**BOARD OF ZONING ADJUSTMENT
STAFF REPORT****Date: September 12, 2011****CASE NUMBER**

5702/5678/5606/2239

Jada and Willie McElroy

LOCATION1350 Arlington Street
(Northwest corner of Arlington Street and Olive Street)**VARIANCE REQUEST****PROTECTION BUFFER:** Variance to waive the requirement of a 6' high wooden privacy fence along the property boundary with adjoining residential property for a commercial site in an R-1, Single-Family Residential District (B-2, Neighborhood Business District use by Variance).**ZONING ORDINANCE
REQUIREMENT****PROTECTION BUFFER:** Requires a 6' high protection buffer wall or fence along a property boundary with adjoining residential property for a commercial site in an R-1, Single-Family Residential District with a B-2, Neighborhood Business District Use Variance.**ZONING**

SITE PLAN

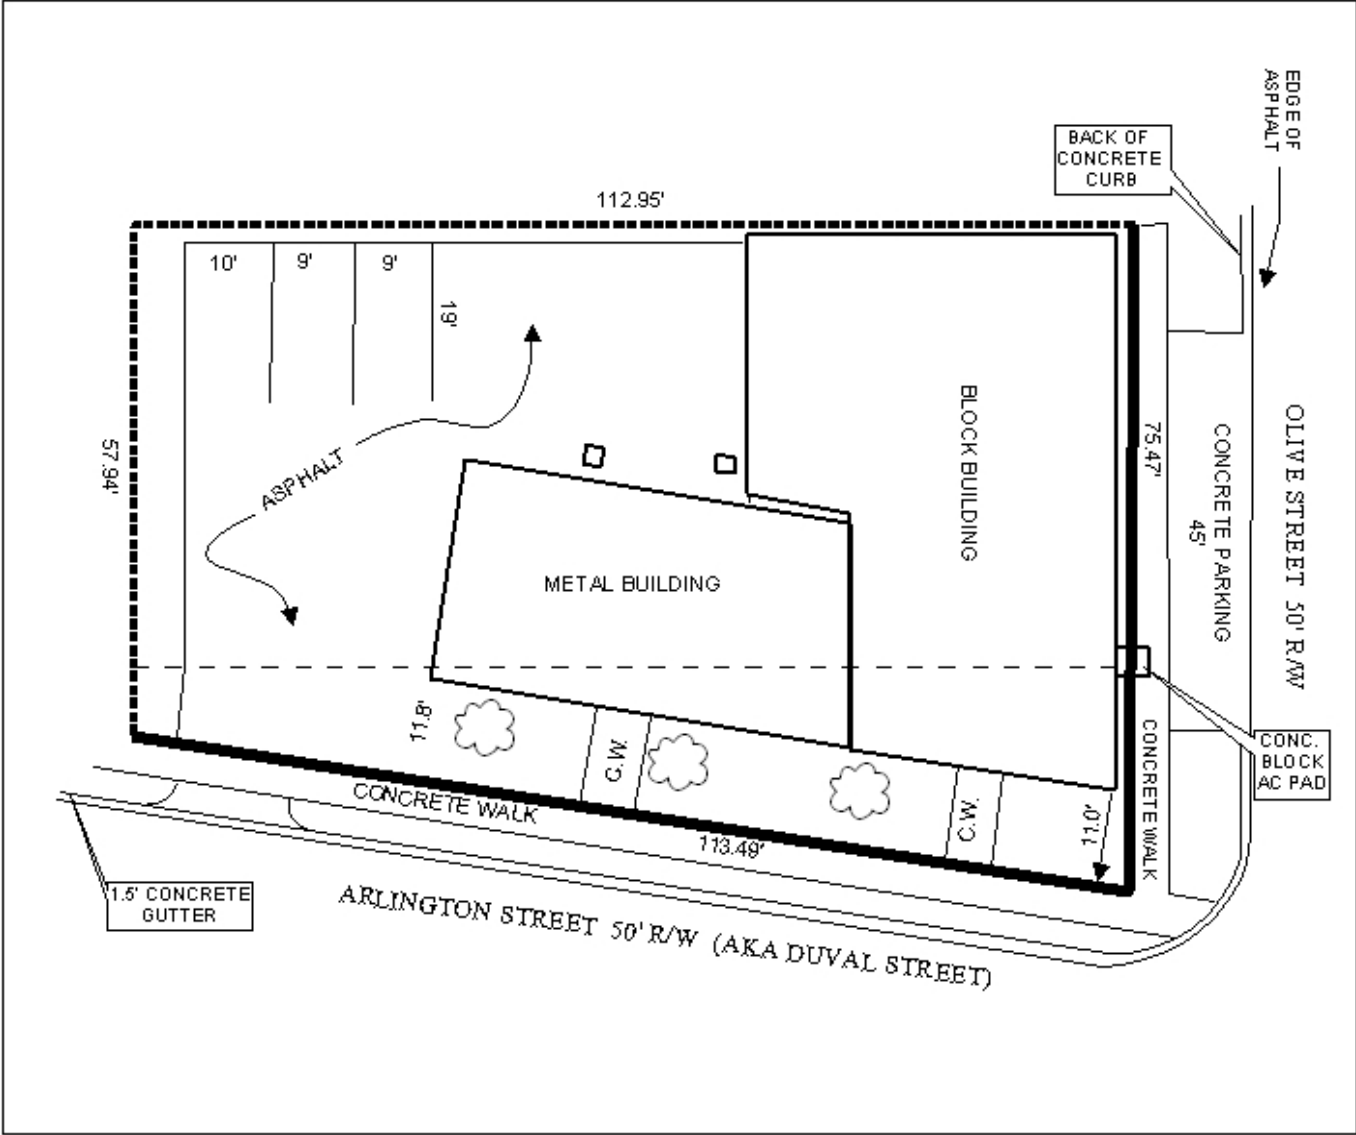
Landscaping Variances. The applicant applied for a land disturbance permit after the previous variances were granted, and it was during the site plan review process that it was discovered that the applicant did not provide a 6' high privacy fence or wall buffer as required by Section 64-4.D.1. of the Zoning Ordinance.

It should be noted that by reducing the visibility of the air conditioning units to passersby that it would reduce the chances of the units being subjected to copper theft. Also, the provision of the 6' privacy fence requirement will reduce the visibility of vehicles in the parking lot to adjacent property owners, making the commercial activity less intrusive on the adjacent residential properties.

RECOMMENDATION:
for denial.
